SERVICE BULLETIN

Service Bulletin No.: DA20-72-03L, Rev. 2

Title: Use of 50/50 Glycol Coolant types to Comply with EASE AD No. 2007-0155

Figure 1 - CHT Cockpit Panel Gauge

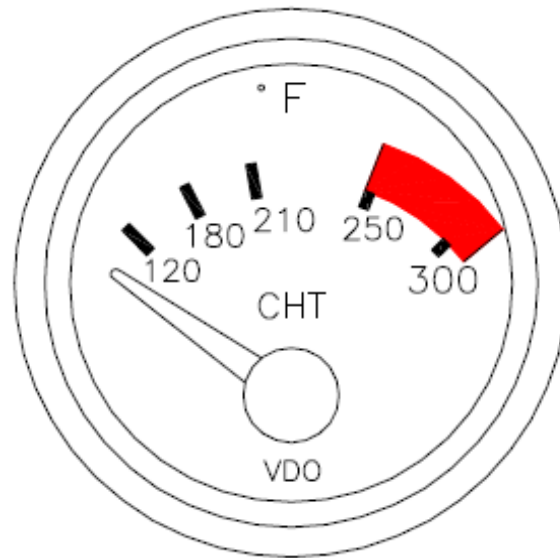
- 10.2.1 Refer to the template on page 5 (Figure 1) of this service bulletin.
- 10.2.2 Use the template to define a radial line on the face of the CHT gauge at 253 °F (122.8 °C) and, an arc from 253 °F (122.8 °C) to 302 °F (150 °C).
- 10.2.3 Mask and carefully etch the surface.
- 10.2.4 Wipe clean.
- 10.2.5 Apply PIN AM210 Aerosol 1K filler primer red paint or equivalent.
- 10.2.6 Allow to dry.
- 10.2.7 Inspect and ensure area is properly marked from 253°F (122.8°C).
- 10.2.8 Above the CHT gauge apply a Placard stating **"MAX CHT = 253°F (122.8°C)"**.

Figure 2 - Radiator Cap

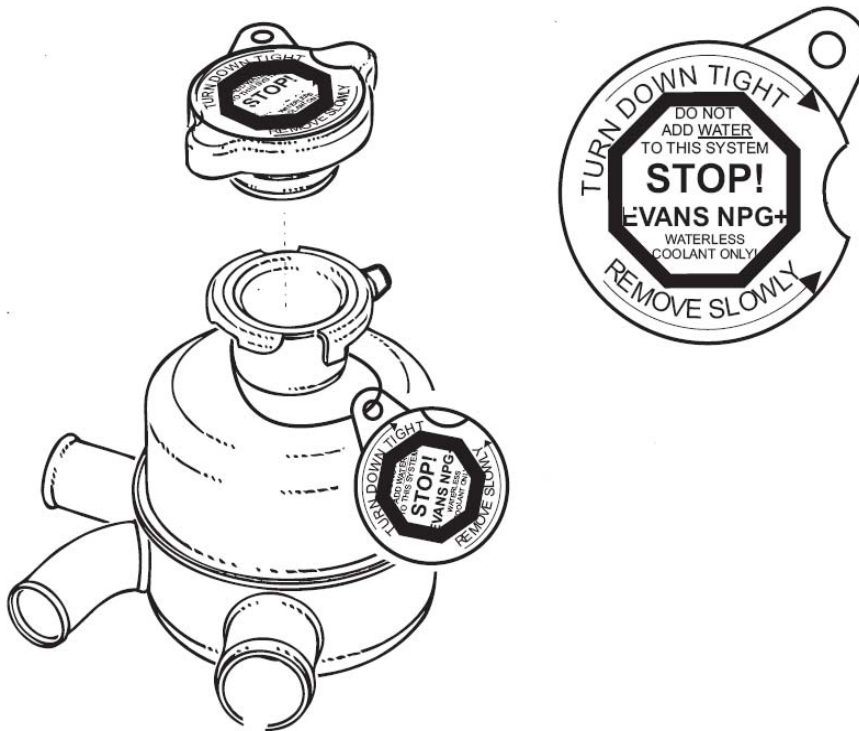
- 10.4.1 Remove the warning label pin 898490 which indicated the use of EVANS NPG+ waterless coolant from the radiator cap.
- 10.4.2 Make the appropriate entry into the aircraft records.

Figure 3 - Engine Wire Routing

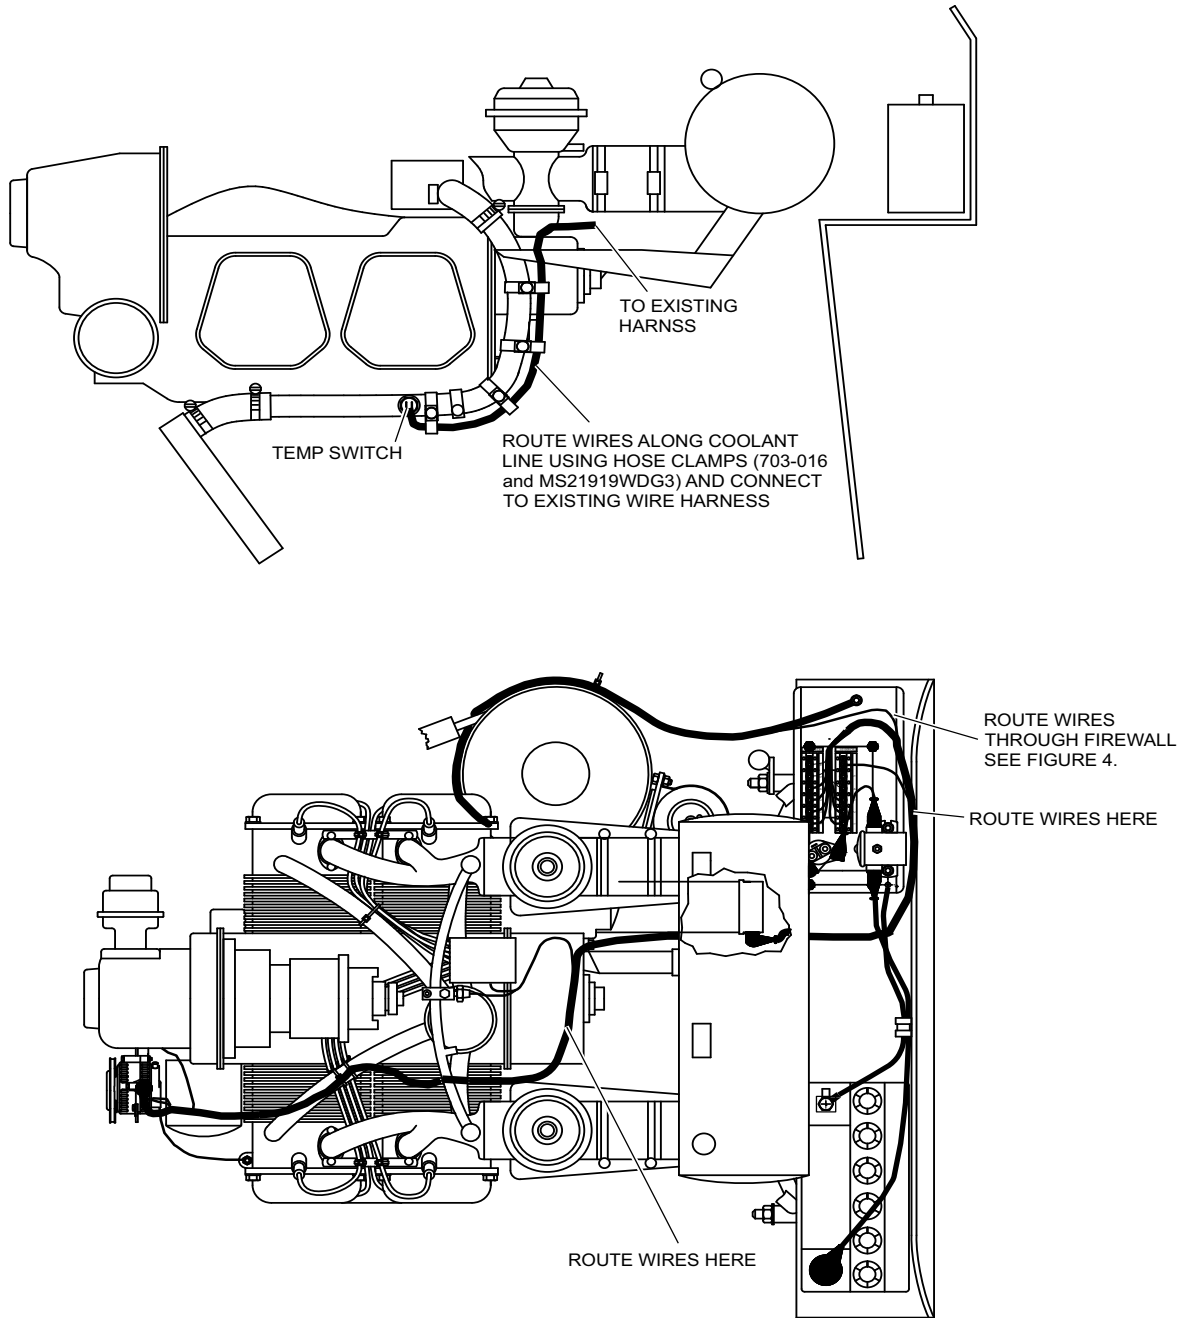
10.3.4 Install the temperature switch. Use a high temperature thread sealer and torque the temperature switch to 3.5 in/lbs. See Figure 3.

10.3.8 Route the wiring along the existing bundles as shown in Figures 3-5. Terminate using applicable ring terminals, fastons and soldering techniques. M22759-34-20-9 or equivalent shall be used. Terminate the wire in accordance with Figure 5.

Figure 4 - Instrument Panel Routing

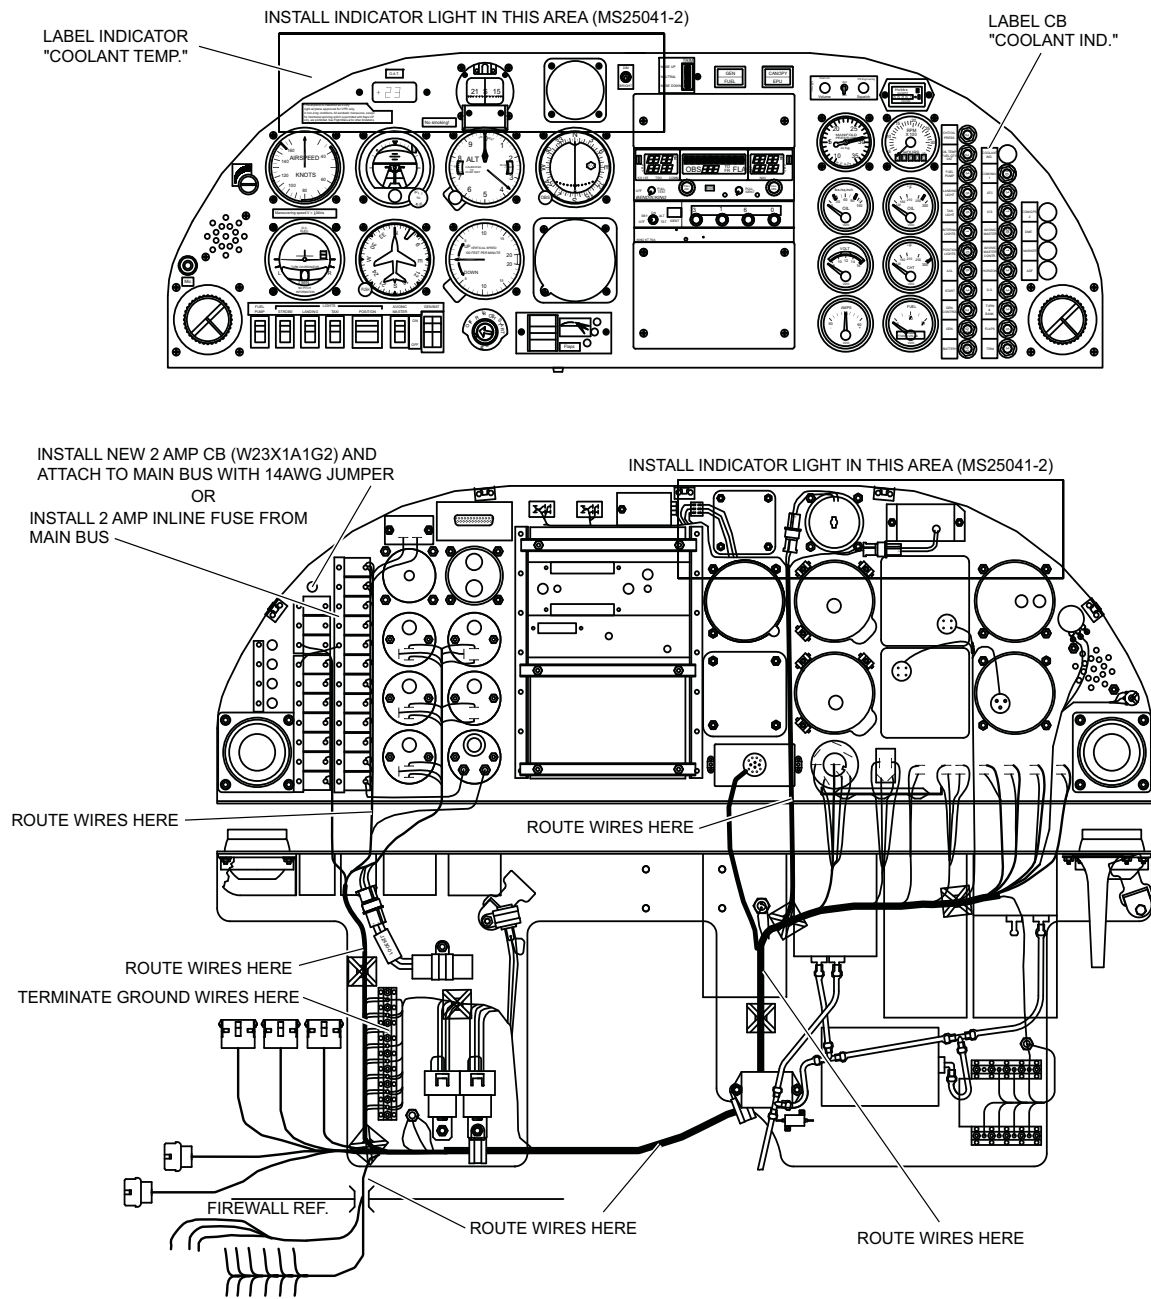
10.3.5 If the circuit breaker panel permits, install a 2 AMP breaker (W23X1A1G2) and connect with a 14 AWG jumper as shown in Figure 4. Label the circuit breaker "Coolant Ind."

10.3.7 Drill a 15/32" hole in the instrument panel as indicated in Figure 4. Install indicator light (MS25041-2). Label the indicator "COOLANT TEMP."

Figure 5 - Schematic

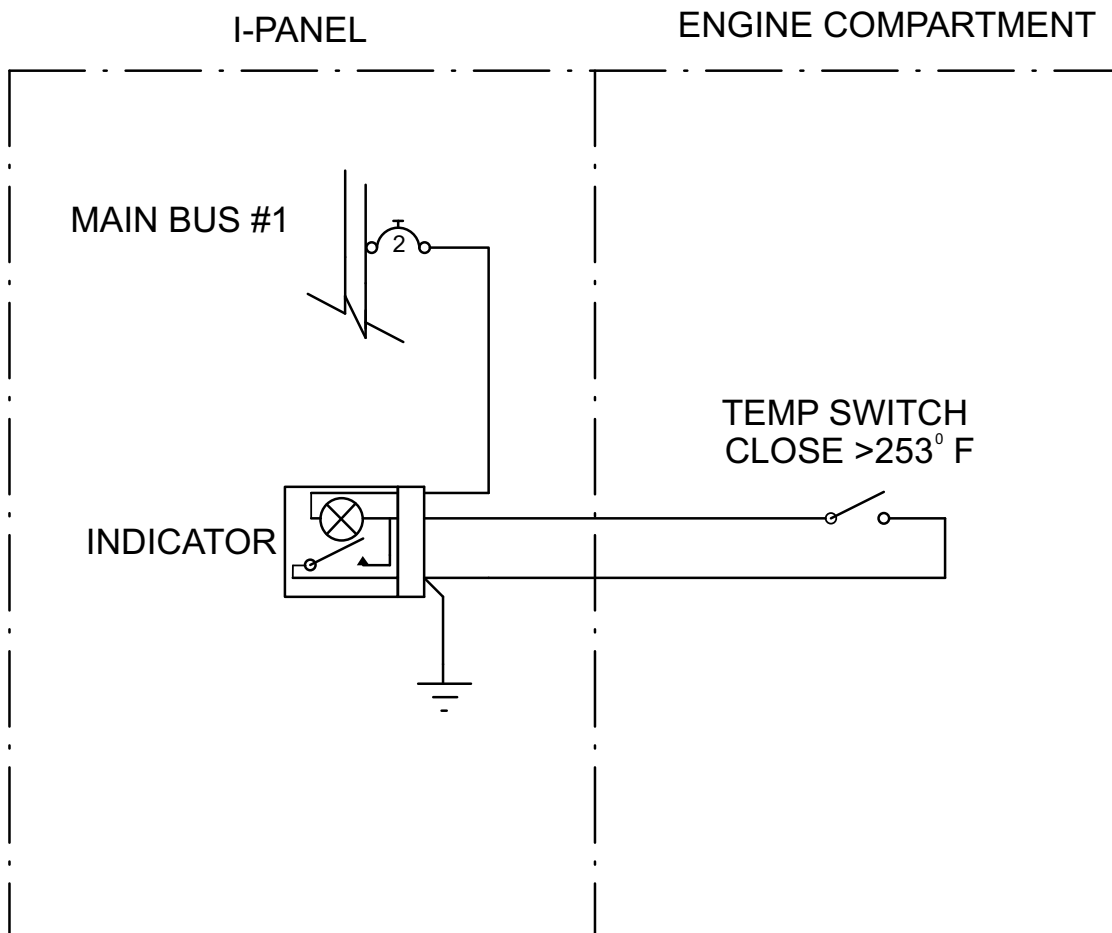
1. USE 20 AWG
